## HISTORIC PRESERVATION COMMISSION

Date: June 26, 2024

SUBJECT: Historic Area Work Permit # 1073431 - Deck Alteration and Expansion

**Deck + Railing Plan**  
Revised 6/20/24

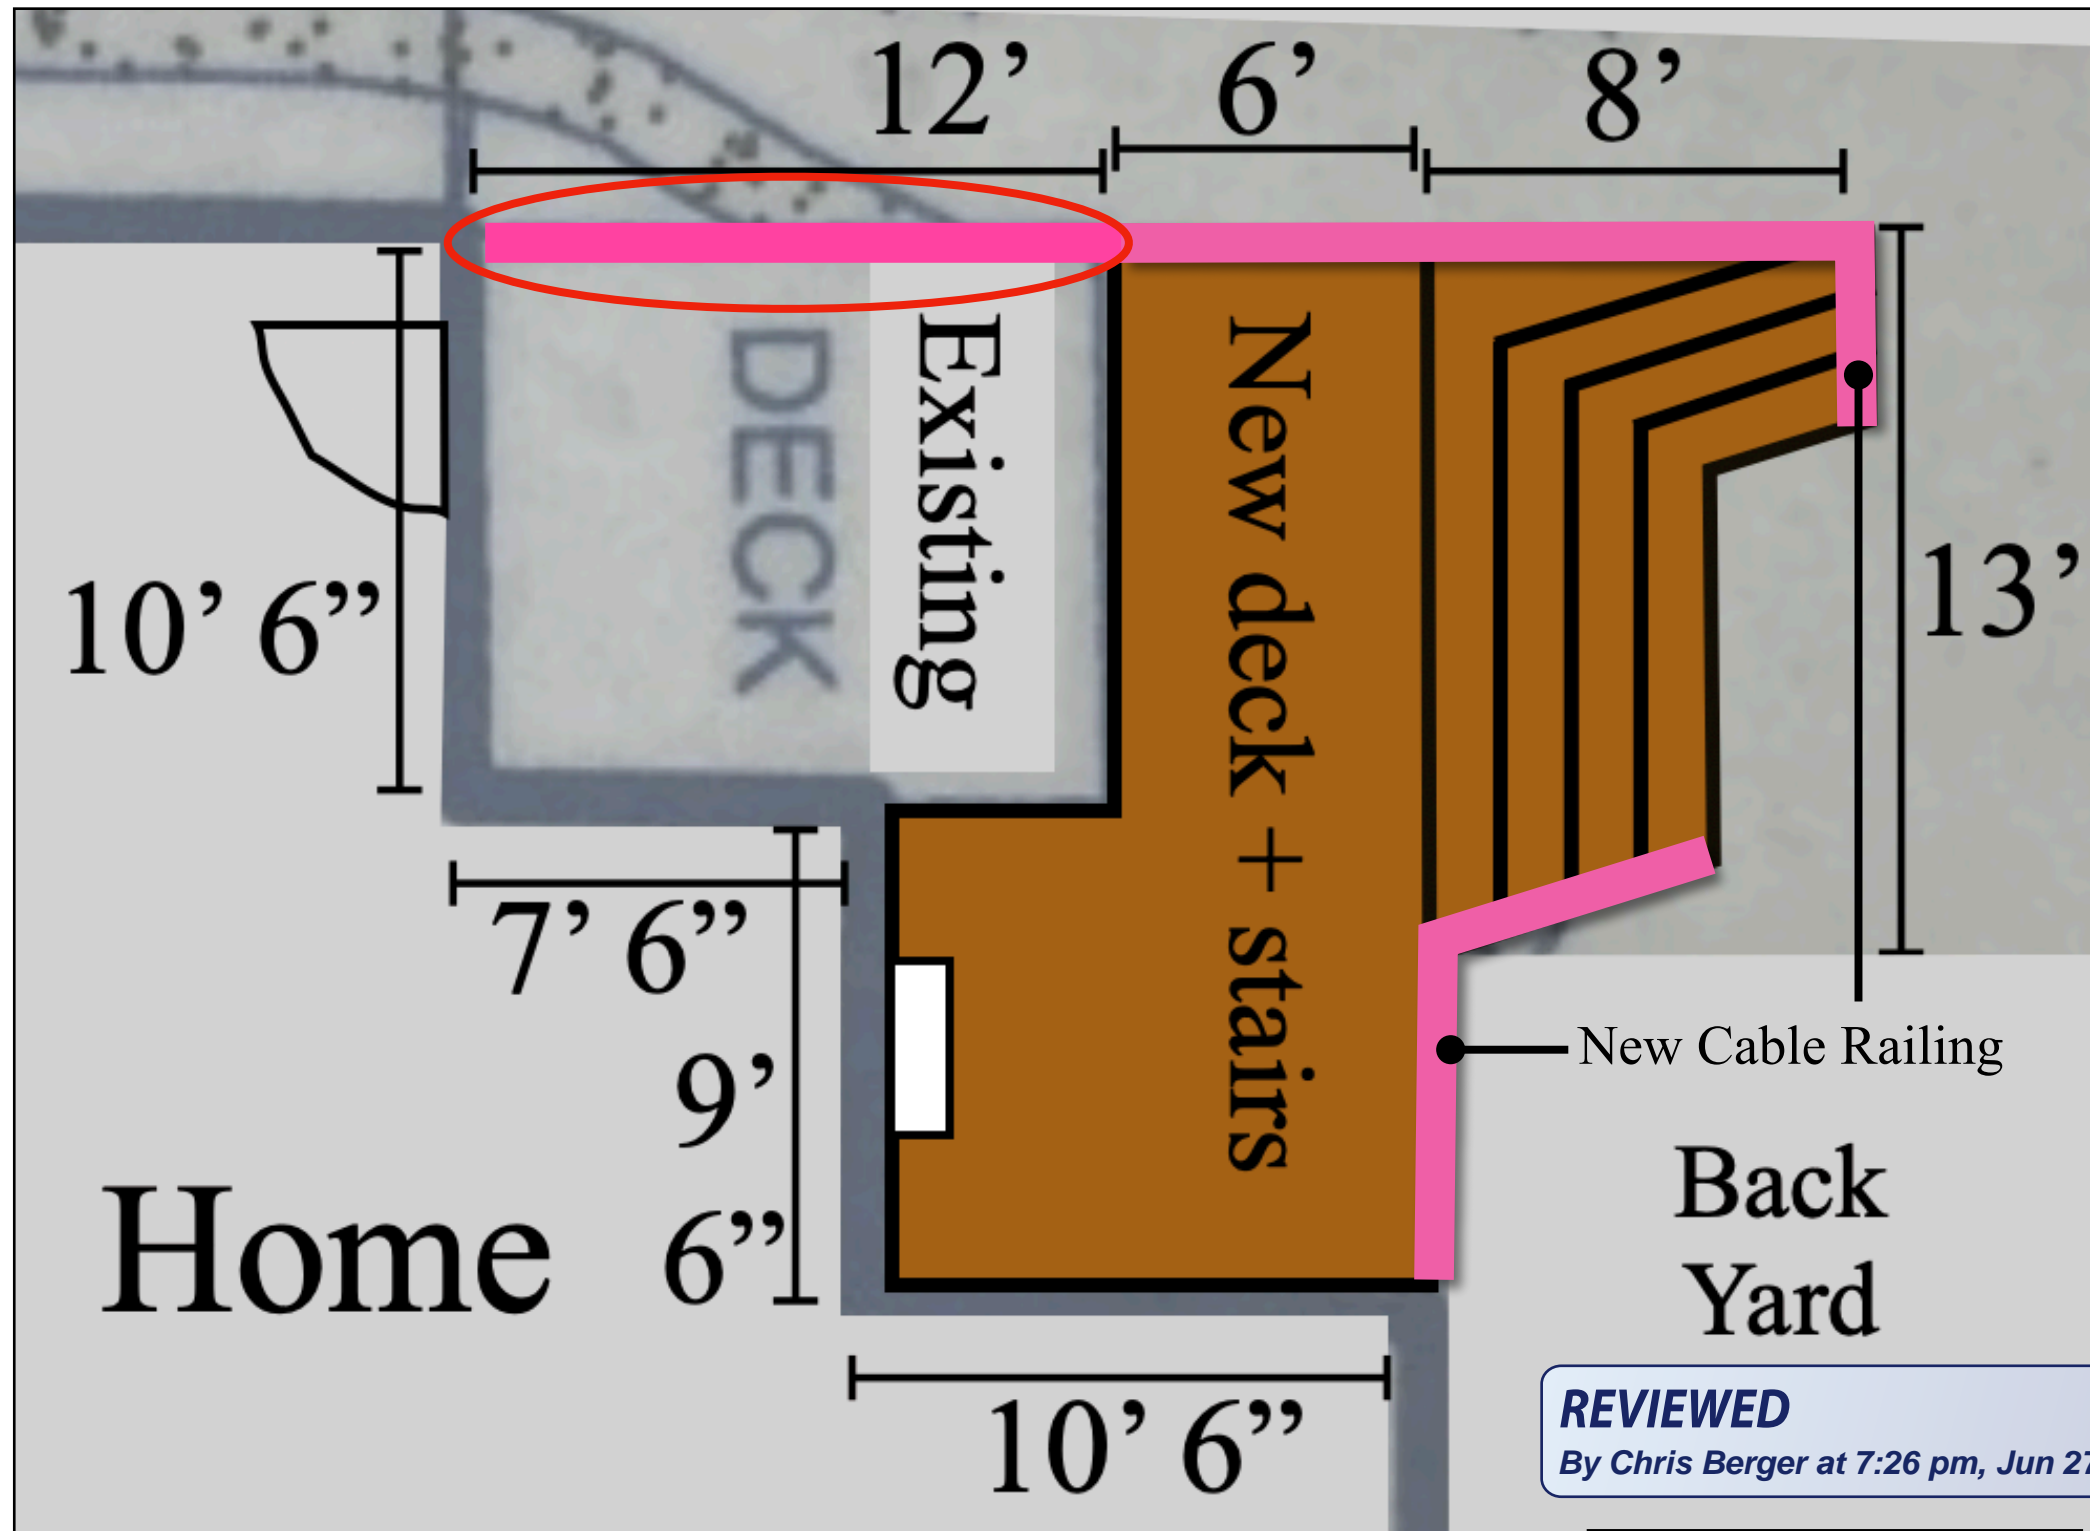
1. Applicant must revise the plans to show the existing railing will be replaced as was stated by the agent in the June 12, 2024, email included as Attachment A to the staff report.
2. Applicant must provide a specification for the composite decking and railing.

**New code compliant rail to be installed along ALL edges of deck**

- Back Deck is NOT visible from public ROW. It sits approximately 75' from, and 15' above, the two nearest sidewalks on Carroll Ave.
- Proposing to expand deck from existing size of 120sf to 300sf as shown on left.
- Existing decking and railing to be removed.
- New decking material to be **Aeratis** paintable composite lumber.
- Railing to be made of wood posts, stainless steel cable, **Aeratis** drink rail with wooden hand rails at stairs.

**Decking Materials**  
 6/20/24

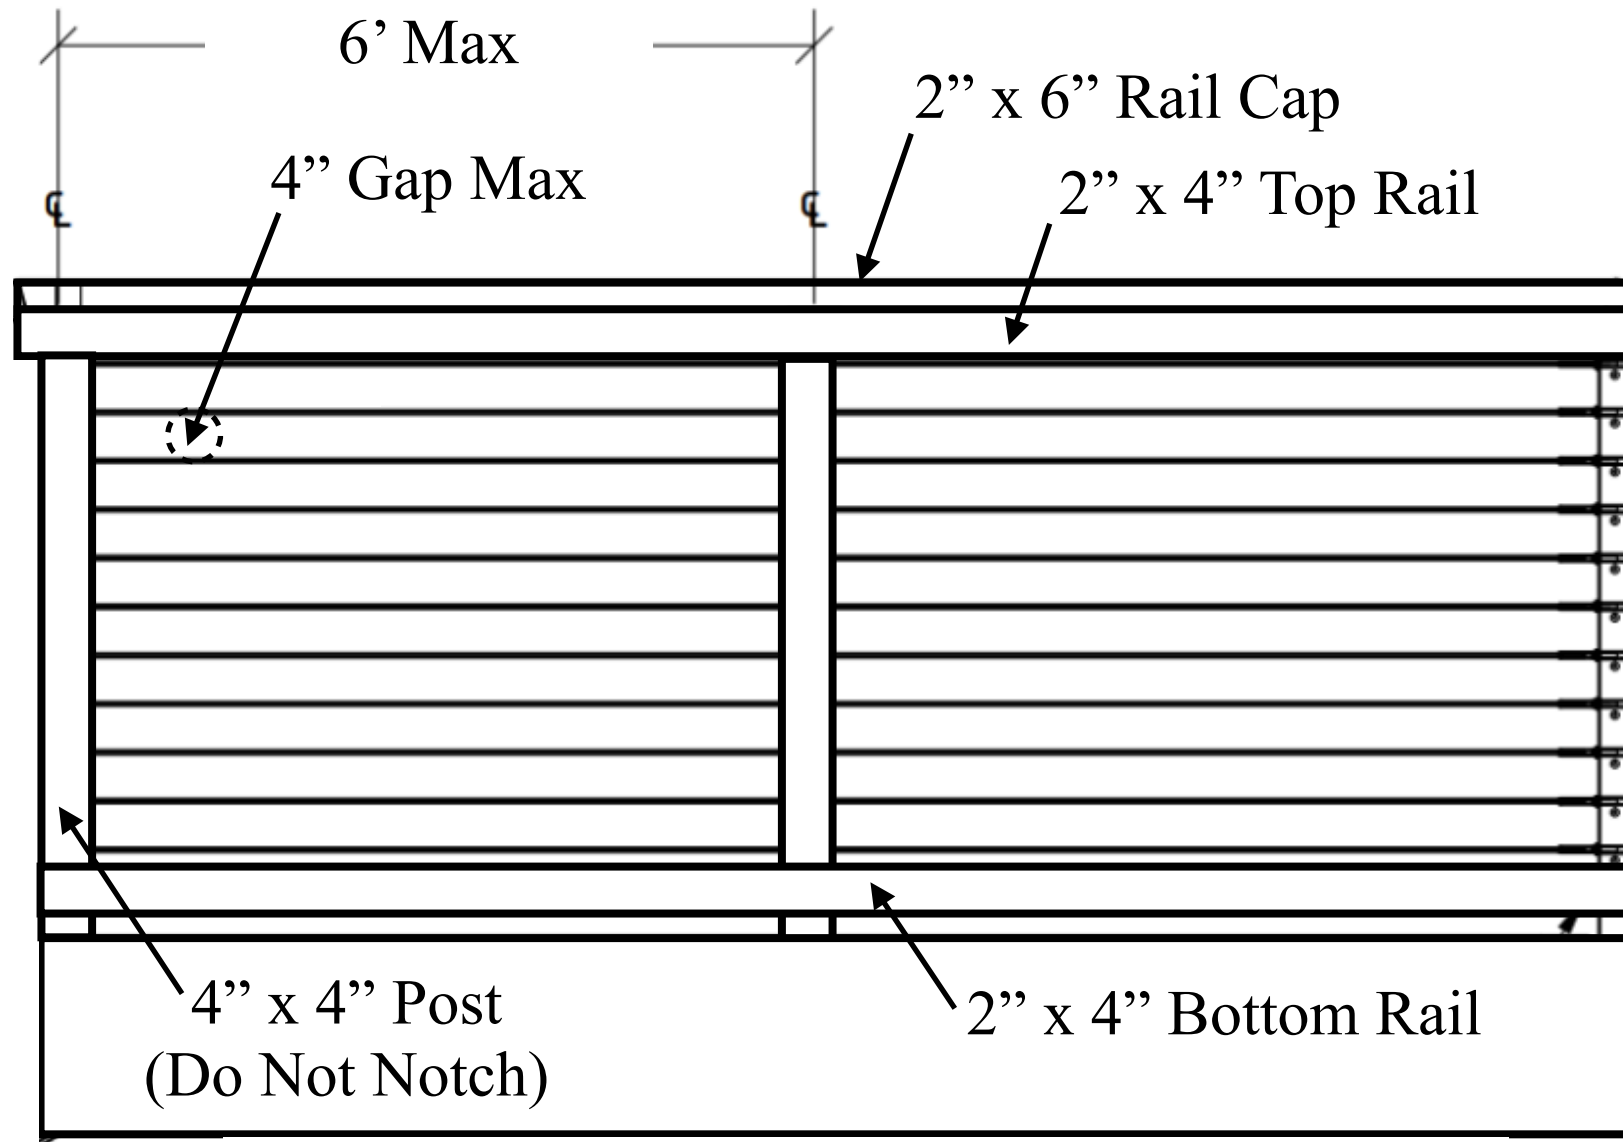
- The Historic Preservation Commission has not approved non-paintable composite decking and railing such as Timbertech for contributing properties in the Takoma Park Historic District. If you would like to proceed with Timbertech, staff will recommend in the staff report denial of that material and installation instead of either wood decking and railings or a paintable composite such as Aeratis or Acre.
- If you change all the deck materials to wood, staff can approve administratively and the work would not require Historic Preservation Commission review.

For the decking material we would now like to use a paintable composite or wood.
